**Subject: Response to Request for Additional Information (RAI) on the Resolution of Unresolved Safety Issue (USI) A-46 (TAC No. M69447)**

OMAHA PUBLIC POWER DISTRICT  
FORT CALHOUN STATION UNIT NO. 1

Response to RAI: Unresolved Safety Issue (USI) A-46

Comparisons of In-Structure Response Spectra  
at Frequencies  $> 8$  Hz  
1.5 Times Bounding Spectrum

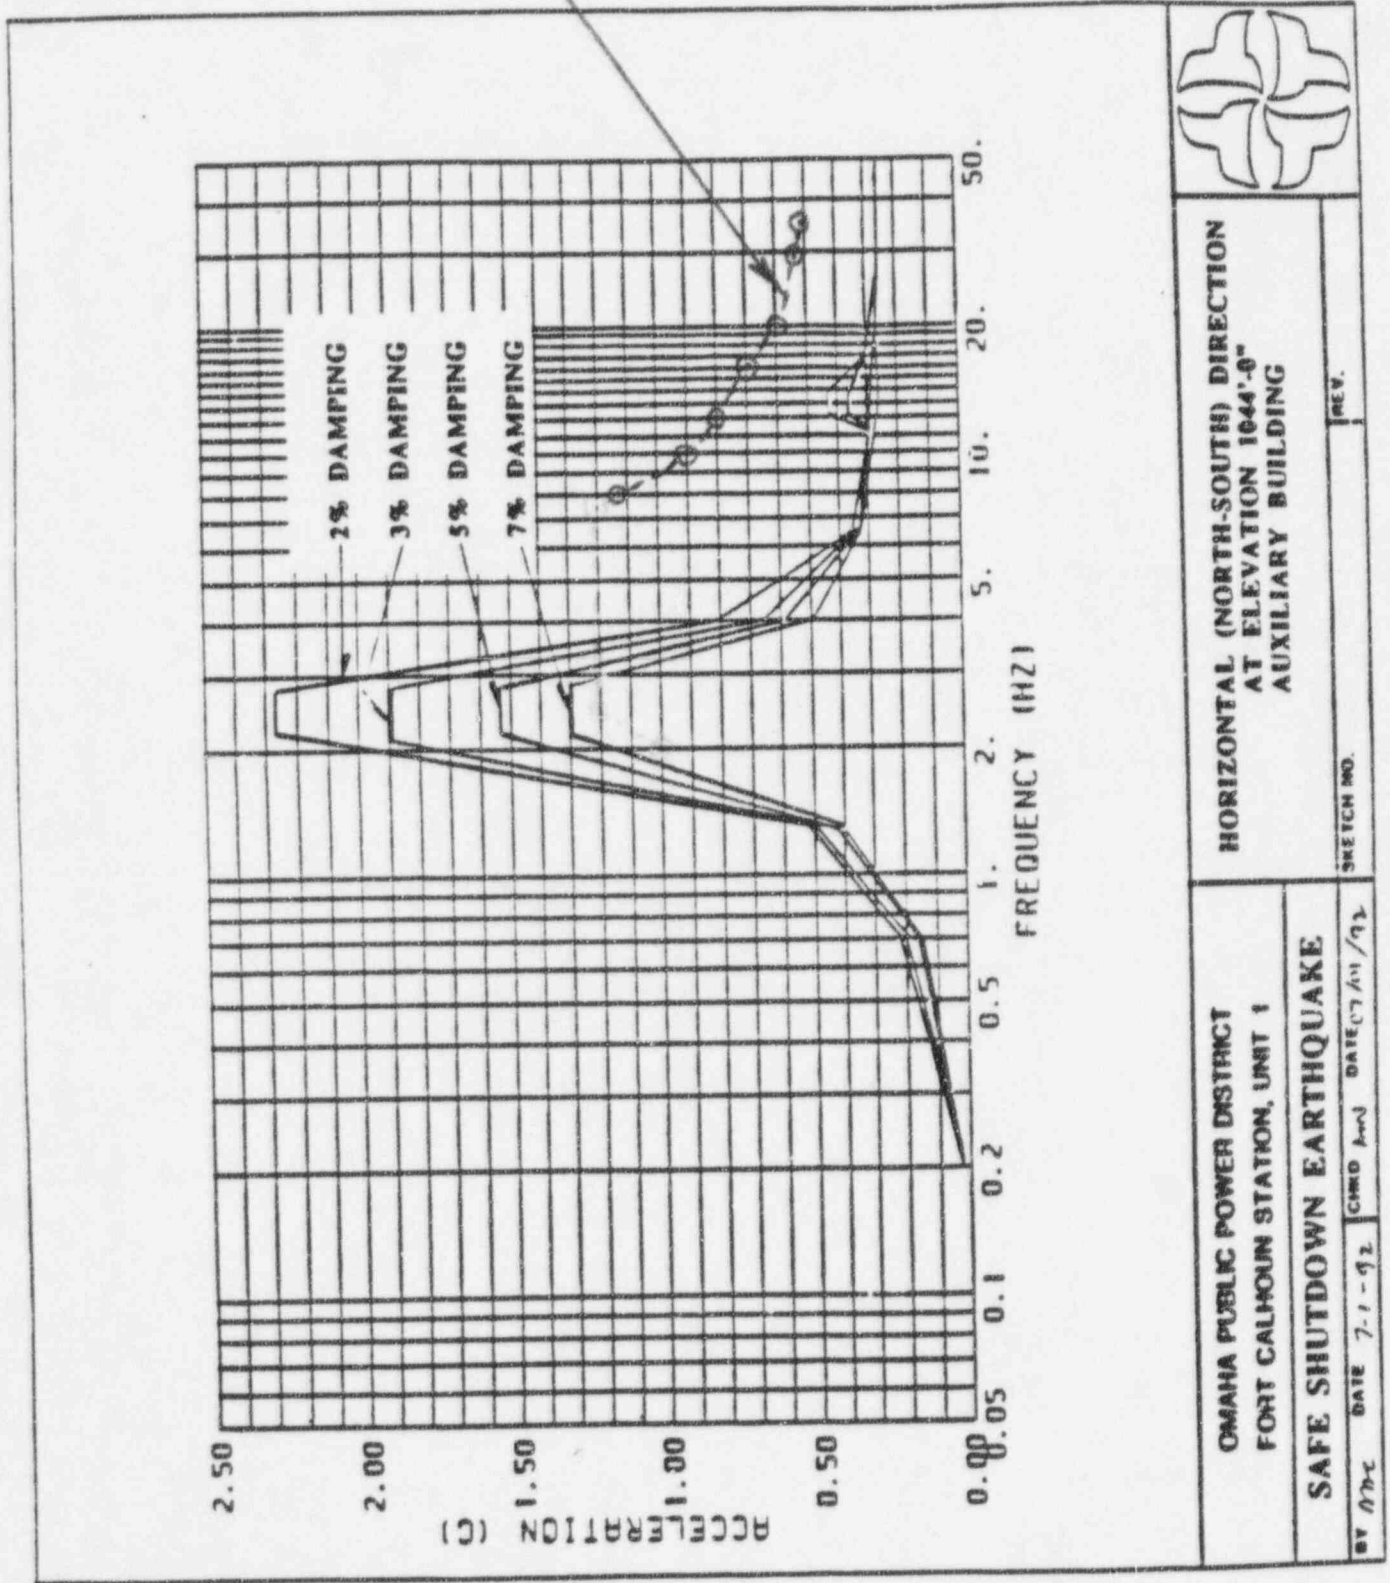
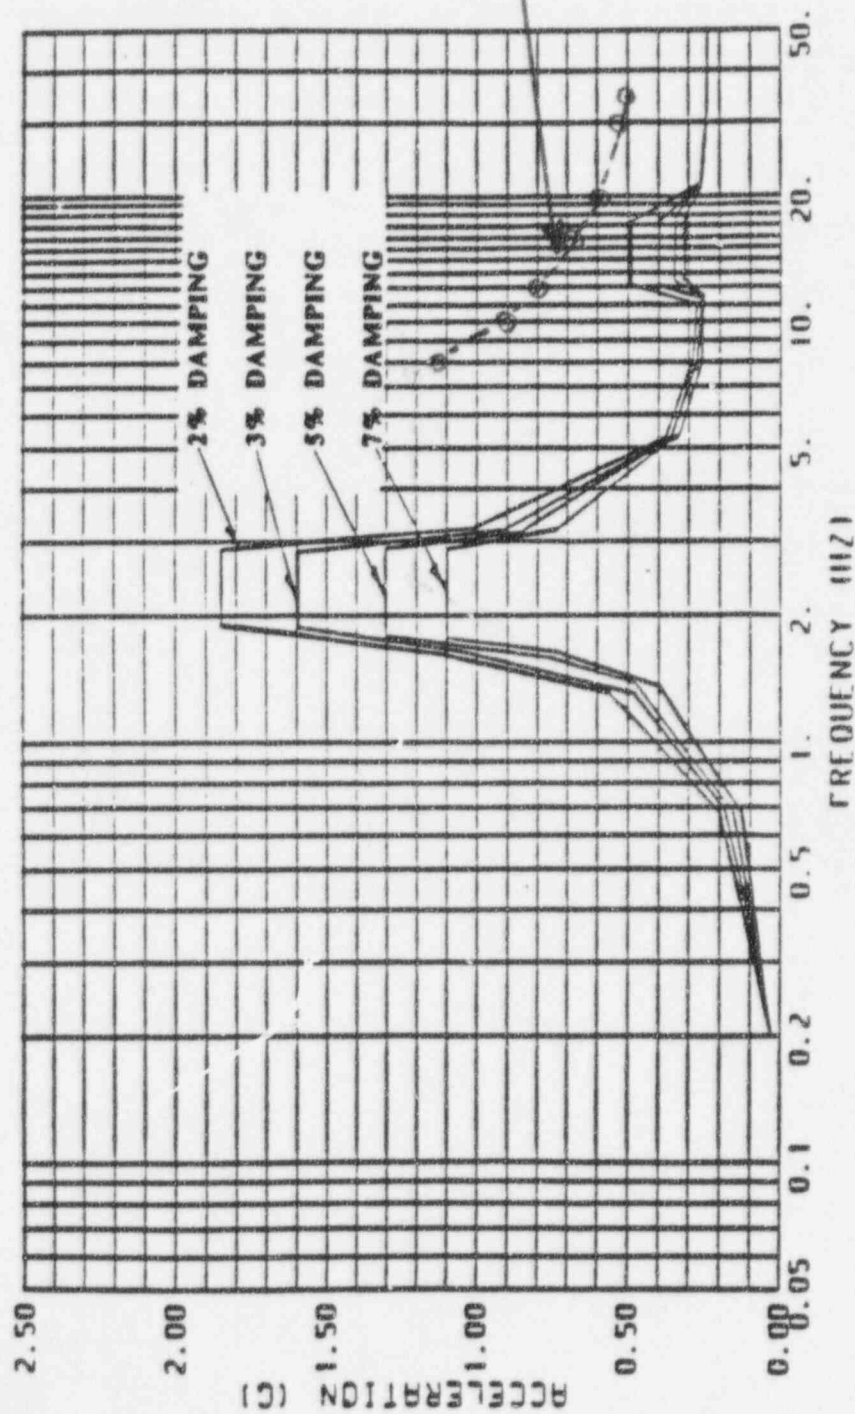
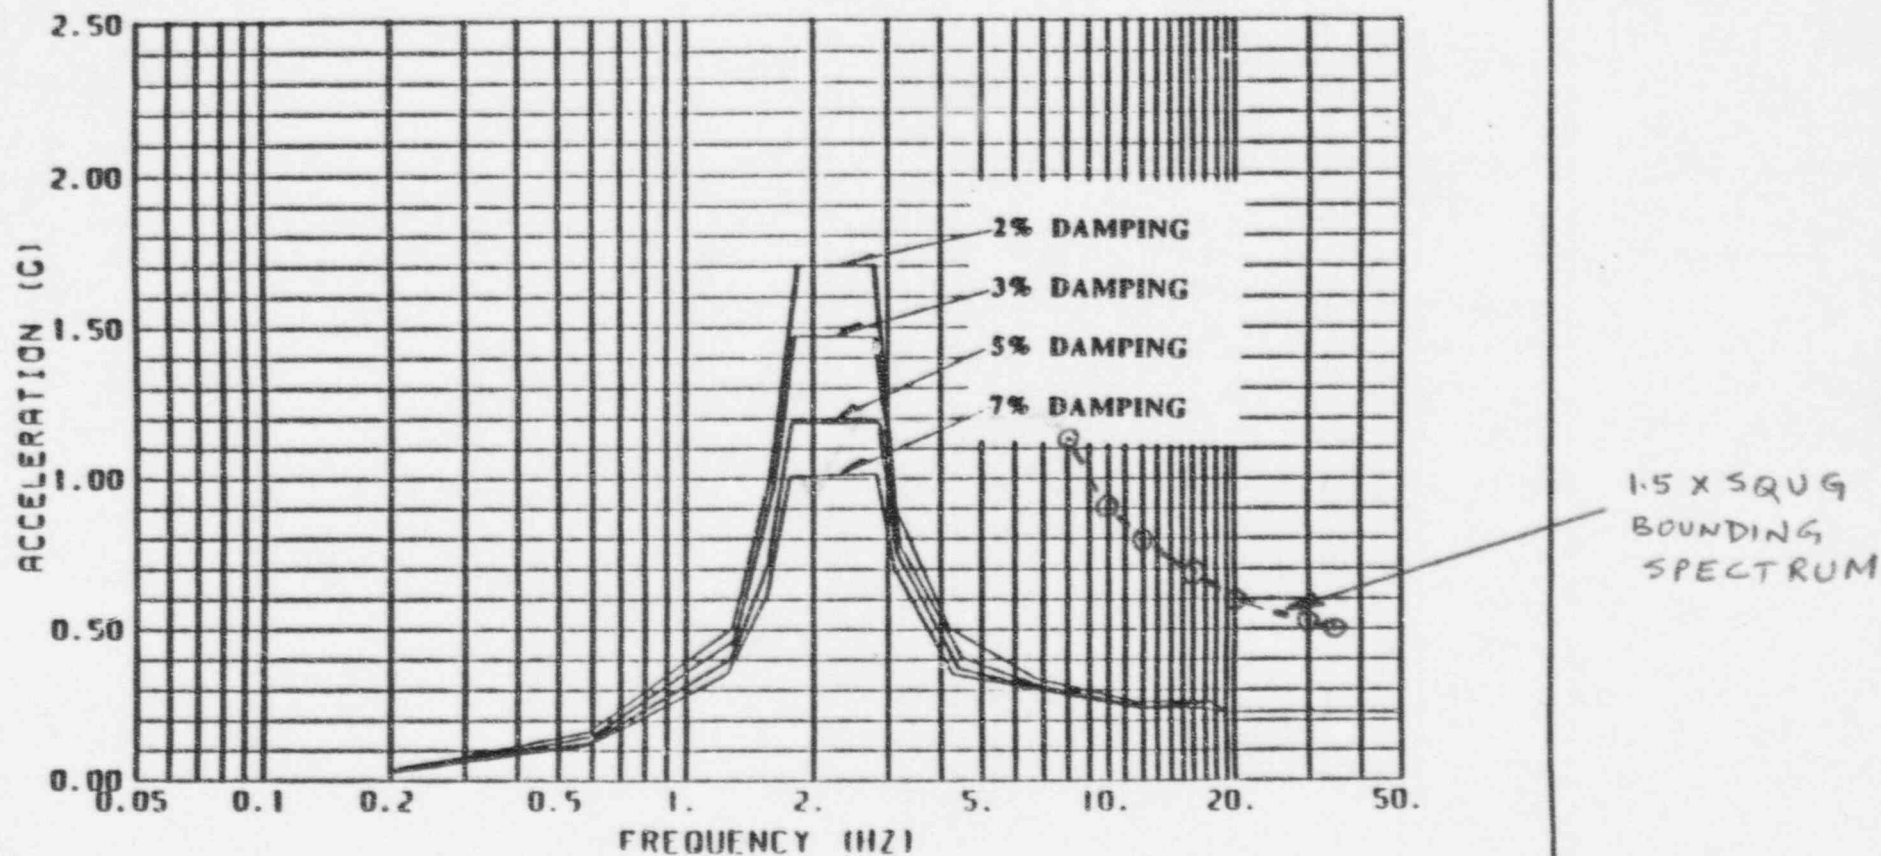
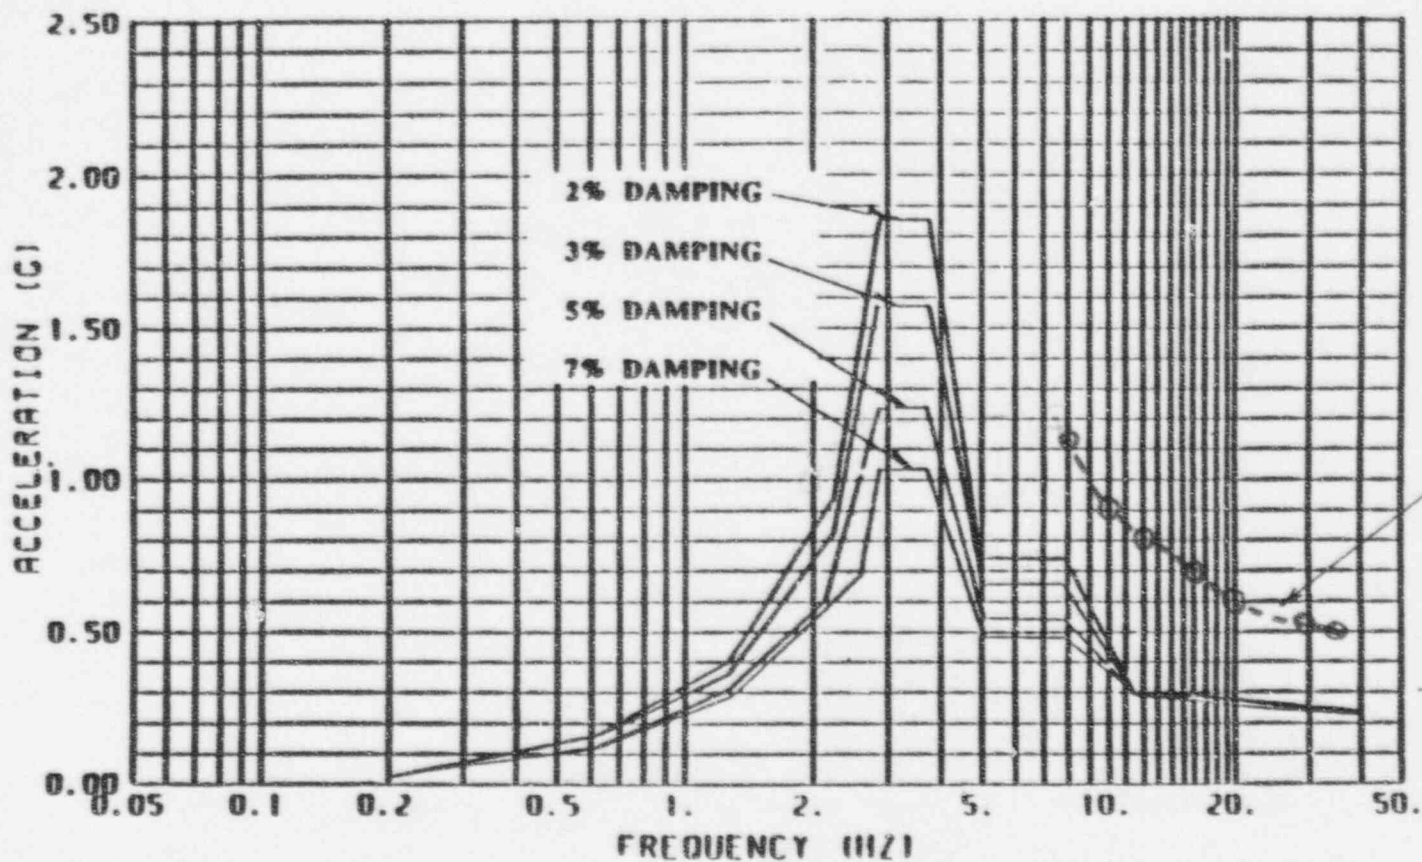
- a. Identify structures which have licensing-basis floor response spectra (five percent critical damping) for elevations within 40 feet above the effective grade, which are higher in amplitude than 1.5 times the SQUG Bounding Spectrum.
- b. Provide the response spectra designated according to height above the effective grade identified in item a. above and a comparison to 1.5 times the bounding spectrum.
- c. With respect to the comparison of equipment seismic capacity to seismic demand, indicate which method (Method A or Method B in Table 4-1 of GIP-2) was used to address the seismic adequacy of equipment installed on those floors as identified in item a. above.

- a. In-structure response spectra for the Auxiliary Building, Internal Structure, Containment Structure, and Intake Structure at elevations within 40 feet above the effective grade (1004 ft.) are bounded by 1.5 times the SQUG Bounding Spectrum, for frequencies greater than 8 Hz.

- b. Typical comparisons of in-structure response spectra, at frequencies greater than 8 Hz, for the four structures noted above and 1.5 times the Bounding Spectrum are provided in Attachment 2. These comparisons are for those elevations in the Auxiliary Building, Internal Structure and Containment Structure which are closest to and within the 1044 ft. elevation (40 ft. above the effective grade), and therefore represent the worst comparison. For the Intake Structure, the comparison is provided for elevation 1007'-6" (the Operating Floor) since all the A-46 components are either at this elevation or below.

FIGURE 2.3 COMPARISON OF DESIGN BASIS GROUND RESPONSE SPECTRUM AND ENVELOPING TIME HISTORY RESPONSE SPECTRUM, NORTH-SOUTH DIRECTION, 5% DAMPING

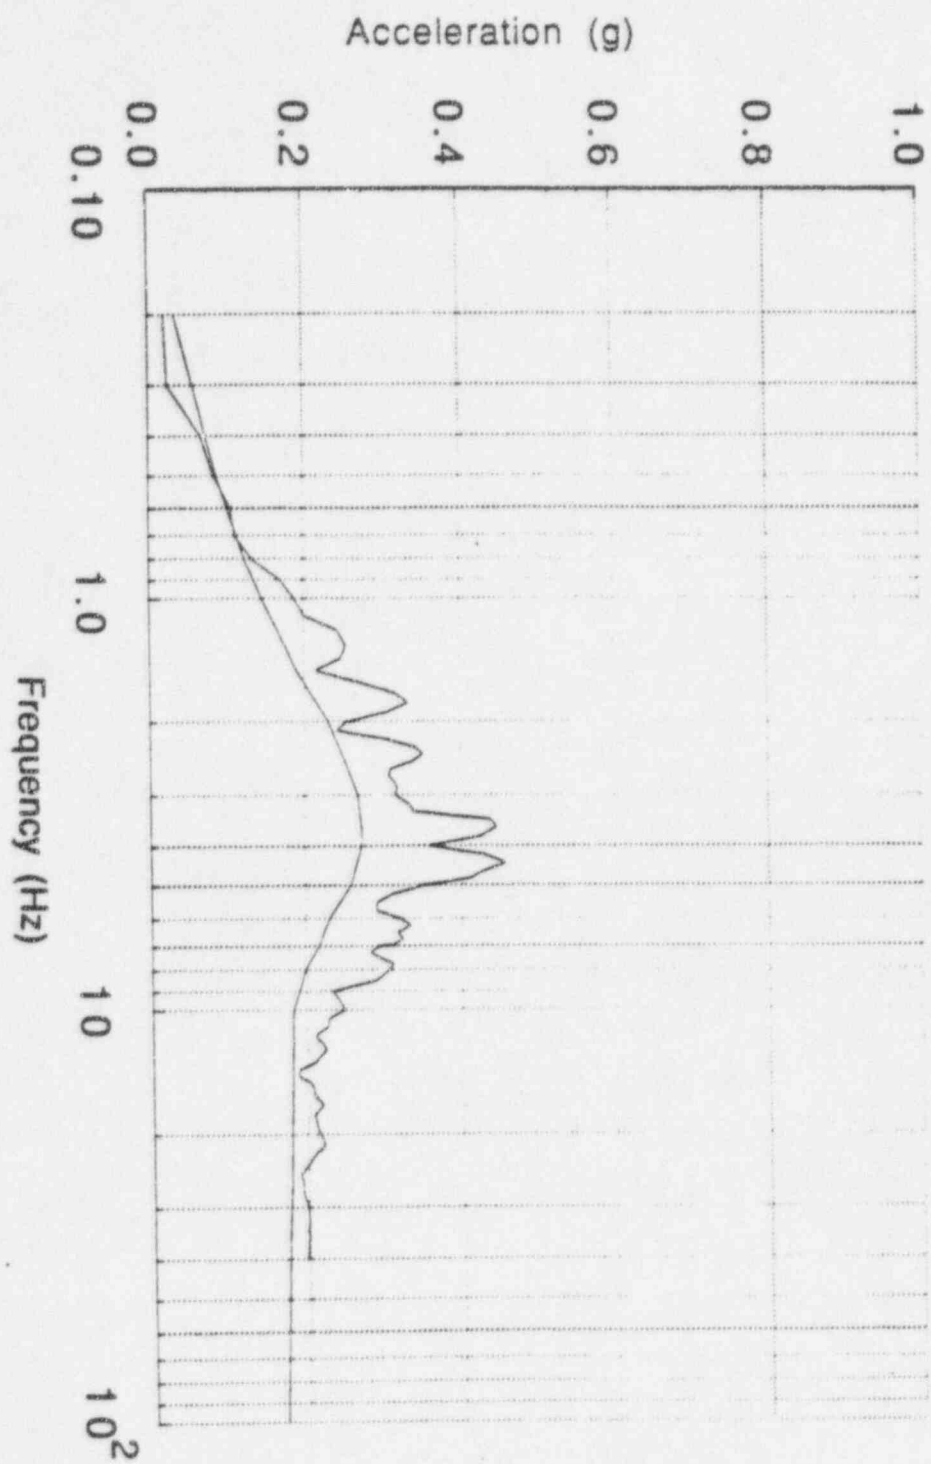
In Section 2.2, Generation of In-Structure Response Spectra (ISRS) for use in A-46 Project, the procedure of scaling the ISRS generated for the Alternate Seismic Criteria and Methodology (ASCM) to the IPEEE motion is described. Provide the rationale in using (a) the 7 percent of critical damping spectral accelerations instead of the 5 percent of critical damping values, and (b) the procedure to scale down the ISRS used in the IPEEE so that they are considerably less than the ASCM spectra originally approved for the Fort Calhoun A-46 review.

- a. In the process of generating the ASCM spectra, a structural damping of 7% was used for the safe shutdown earthquake (SSE). Therefore, in the determination of the scaling factor, the 7% damped ground level spectra were used.

Use of the 5% damped spectra for scaling purposes would not make any significant difference. For example, using the 0.64g peak spectral acceleration value for the 5% damped NUREG CR/0098 spectrum (corresponding to 0.3g maximum ground acceleration), and an acceleration of 0.32g obtained from the 5% damped ground time history spectrum over the same frequency range of 2.4 to 2.9 Hz for the upper bound soil properties, a scale factor of  $0.64/0.32 = 2.0$  is obtained instead of 2.04, which was obtained originally using the 7% damped spectra. (See Attachment 3, Figure 2.3 of Reference 6 in the ASCM Report). Similar results are expected for other buildings and directions as well.
